# Wivenhoe Dam Operation for Flood Mitigation

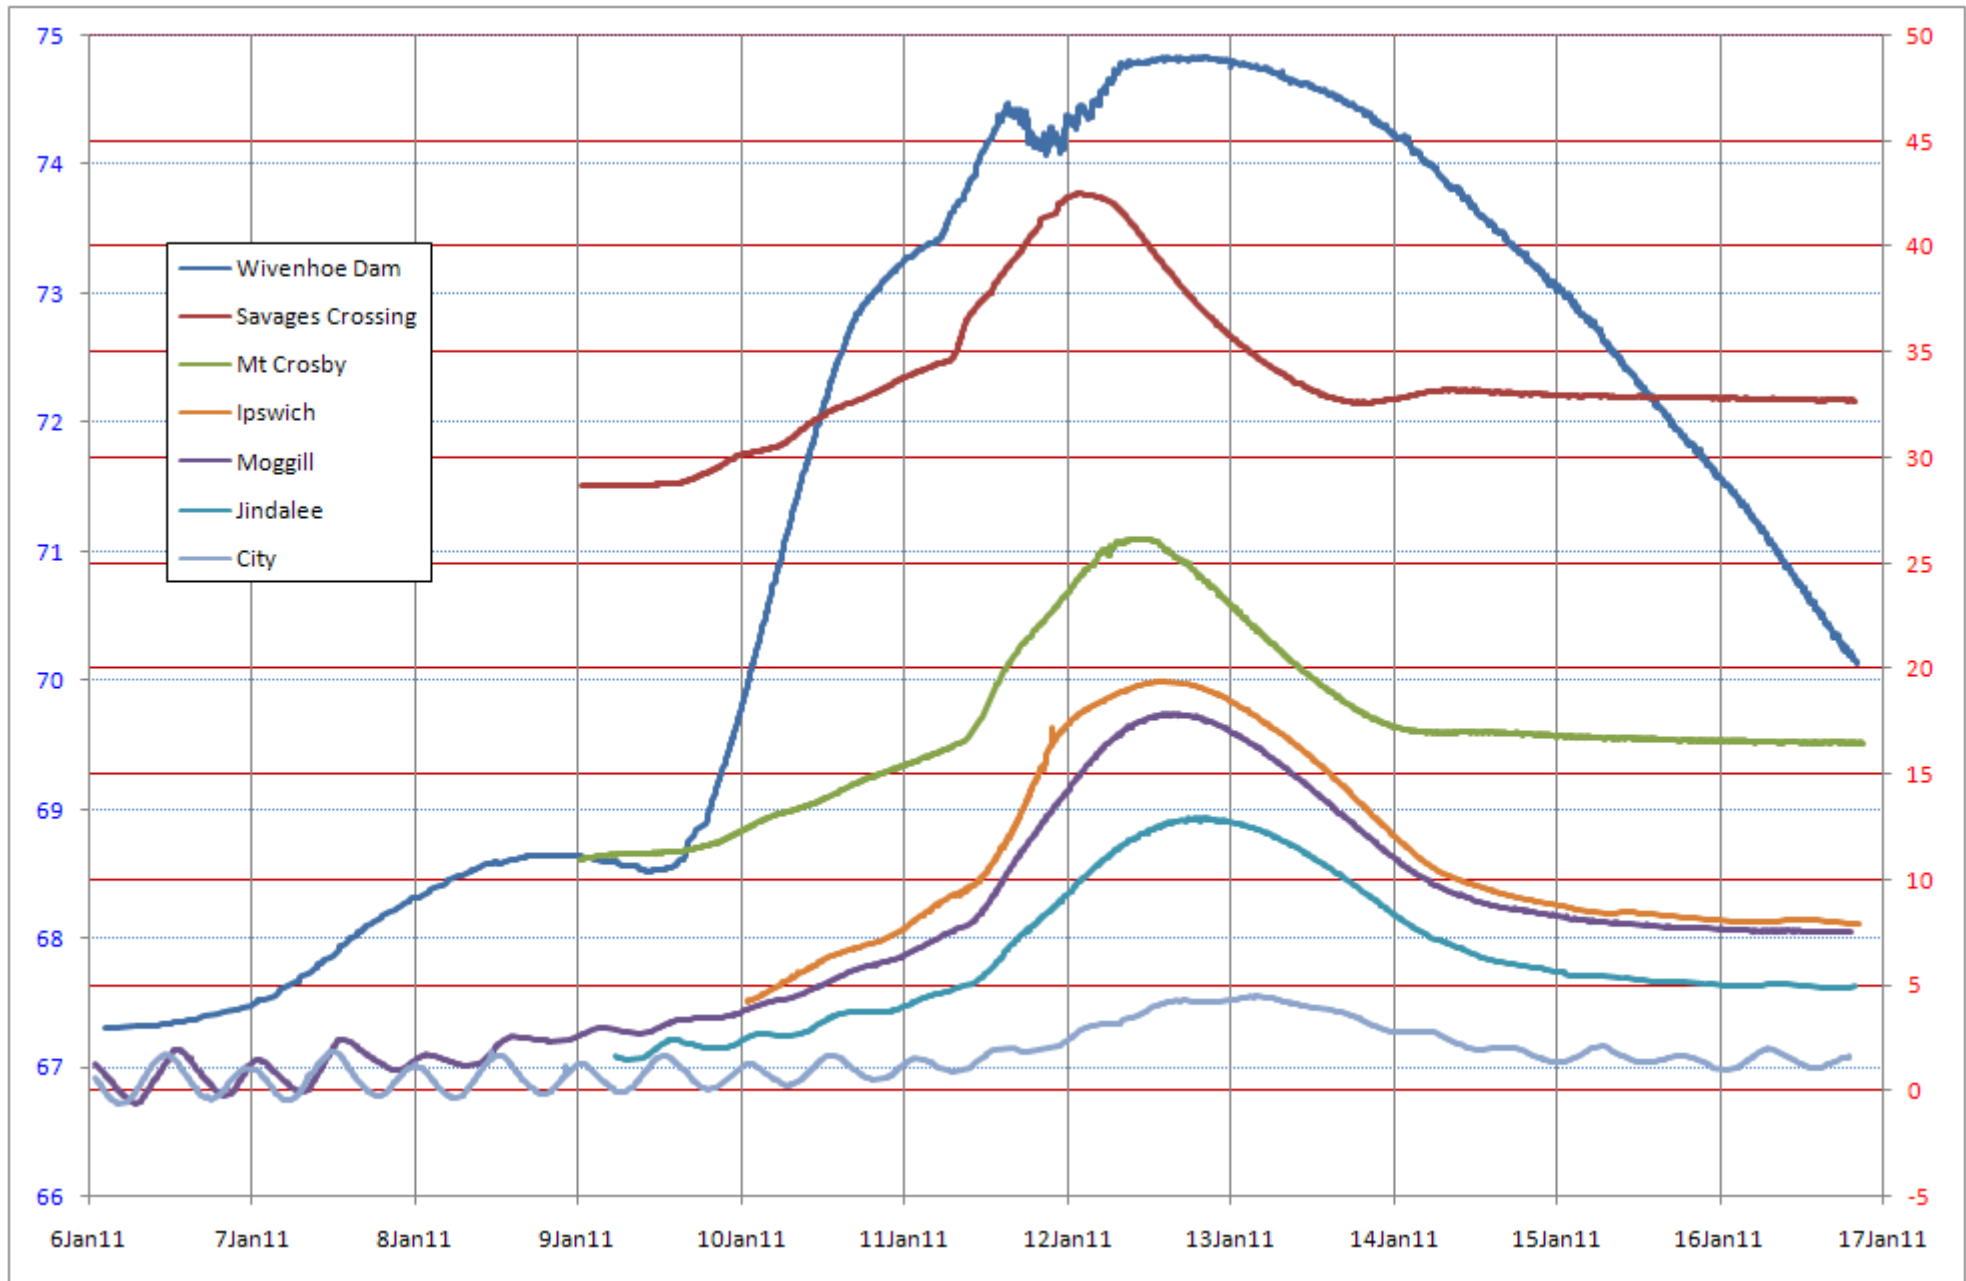
The river levels that in the Brisbane River flood event of 11-13 January 2011 are plotted on the graph appended to this submission. The level gauge in Wivenhoe Dam is somewhat erratic in the critical period, but is assumed to give a reasonable indication of trends when smoothed.

Also appended is an enlarged graph of the Wivenhoe Dam level over the two days 11-12 January 2011.

I do not have access to seqwater's release records, but referring to the dam's capacity curve, the water levels indicate that:

- between 10:30am and 3pm on 11 January the net inflow to the dam averaged 4,300 cumecs, and
- between 3pm and 8:45pm on 11 January the net outflow from the dam averaged 3,000 cumecs.

**It is apparent that no significant gate closing occurred for 5¾ hours after the water level began to fall at 3pm on 11 January. This could be considered a departure from the Operational Manual – and a contribution to the flood peak.**
